Broadcast Products Technical Bulletin 20-2003-144

SUBJECT: REUSE IC1 WHEN REPLACING GA BOARD

MODEL: **BVM-1311**
BVM-1315
BVM-1316
BVM-1316C
BVM-1911
BVM-1912
BVM-1912/F
BVM-1915
BVM-1916

Figure 1

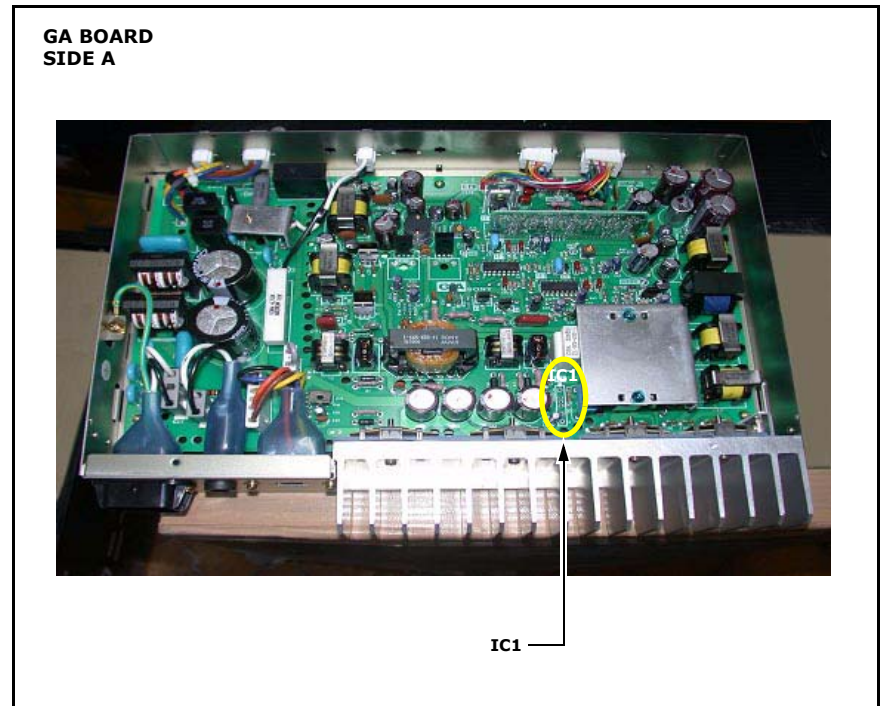
The new GA board does not contain IC1, and IC1 is no longer available as a service part. (See Figure 1.)

When replacing the GA board (A-1316-089-C), remove IC1 (1-806-805-11) from the former board and solder it to the new board.
